INSTITUTIONAL CASEWORK, INC.
1865 Highway 641 North
Paris, Tennessee 38242-8814
(731) 642-4251

DATE: 1/25/2017
JOB: 04437A, B, C, D
RE: Webster University
Webster Groves, MO

COPIES	DATE	NO.	DESCRIPTION
1	1/25/17	04437ARI -E2 and 04337BRI -E4	Rough-In & Elevation Shop Drawings
1	1/25/17	04437DETAILS1 & 04437DETAILS2	Cabinet Sections
1	1/25/17	04437OHSC	OHSC detail/quantities Sheet
1	1/25/17	Set	Project Data Document

PEGBOARD

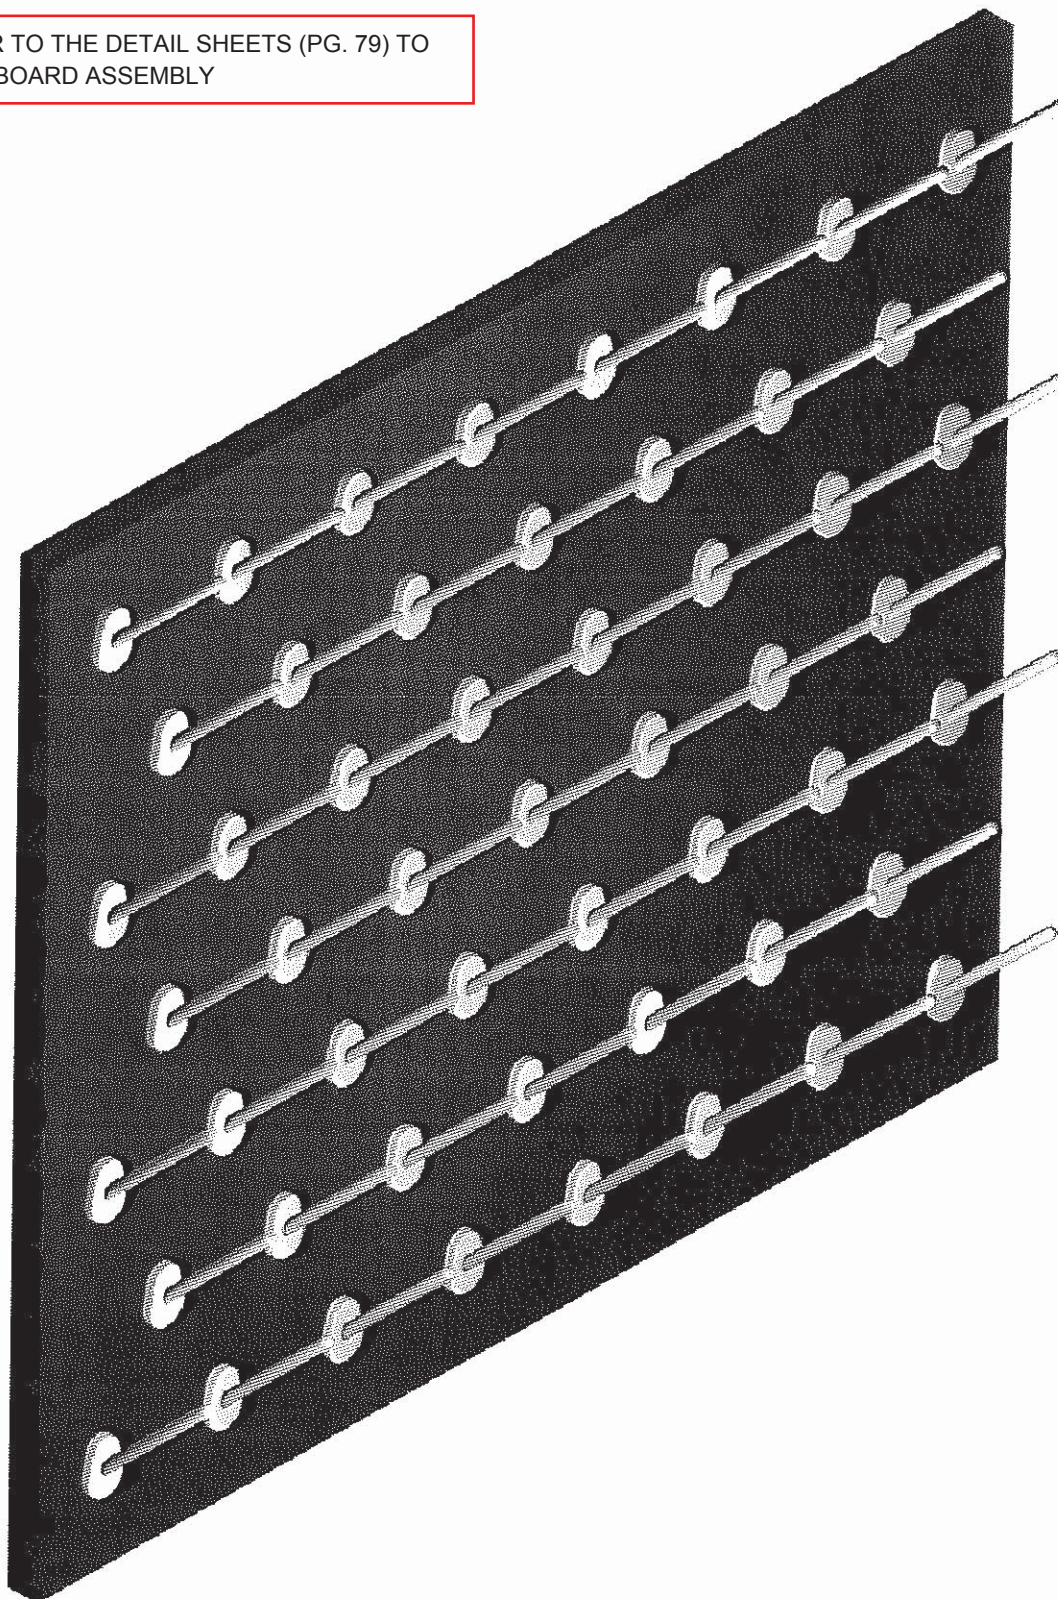
GENERAL COMMENTS:

-ALL LAB CASEWORK TO MEET PERFORMANCE REQUIREMENT INFORMATION PER SPECIFICATION (SPEC.) 123553,1.3,A.

-TABLES TO MEET UL REQUIREMENT PER SPECIFICATION 123553,1.3,D.

-EW, DH & PRE-RINSE FIXTURE APPROVAL ON HOLD.

-ALL CABINETS (WOOD, METAL, FLAMMABLE, ACID) TO BE FLUSH OVERLAY.

-PRODUCT DATA FOR MOBILE LAB CASEWORK SYSTEM WHICH WAS PRESENT IN PREVIOUS SUBMITTAL WAS DELETED IN THIS RE-SUBMITTAL. THE MOBILE LABORATORY CASEWORK SYSTEM IS APPROVED PROVIDED IT IS ONE OF THE APPROVED MANUFACTURER PER SPECIFICATIONS, JAMESTOWN METAL PRODUCTS PER PREVIOUS SUBMITTAL. PROVIDE WRITTEN CONFIRMATION TO DOCUMENT THE MANUFACTURER & PRODUCT MEETS SPECIFICATIONS.

-PROVIDE WHITE COLOR CYLINDER RACKS.

-ALL PRE-WIRED TABLES CONNECTING TO FLOOR BOXES TO HAVE STANDARD ELECTRICAL PLUG.

-COORDINATE ALL ELECTRICAL OUTLETS WITH ELECTRICAL DRAWING & SPECIFICATIONS. TECHNICAL SPECIFICATIONS PER ELECTRICAL DRAWINGS.

PROVIDE SEPARATE SUBMITTAL FOR FOLLOWING:

-PROVIDE LOAD CAPACITY OF TABLES.

-PROVIDE SEPARATE SUBMITTAL OF TEST REPORTS FOR COUNTERTOP PER SPEC. 123553,1.5,C.

-HEAVY DUTY SLIDE PRODUCT DATA FOR GRADE 1HD-100 & 1HD-200 PER SPEC. 123553,2.12,E.

-PROVIDE PRODUCT DATA FOR V-5 AND A-5 (QUICK DISCONNECTS).

-PROVIDE PRODUCT DATA FOR E-5, E-6, D-5, D-6

-PROVIDE PRODUCT DATA FOR PAPER TOWEL DISPENSER.

-PROVIDE PRODUCT DATA FOR OVERHEAD SERVICE CARRIER & MOBILE LABORATORY CASEWORK SYSTEM (IDENTIFY MANUFACTURER).

-PROVIDE PRODUCT DATA FOR EPOXY COUNTERTOPS.

-PROVIDE SAMPLE & INFORMATION RELATED TO SIGNAGE FOR ACID (CORROSIVES) & FLAMMABLE CABINETS - CONSISTENT CLEAN GRAPHICS LETTERING.
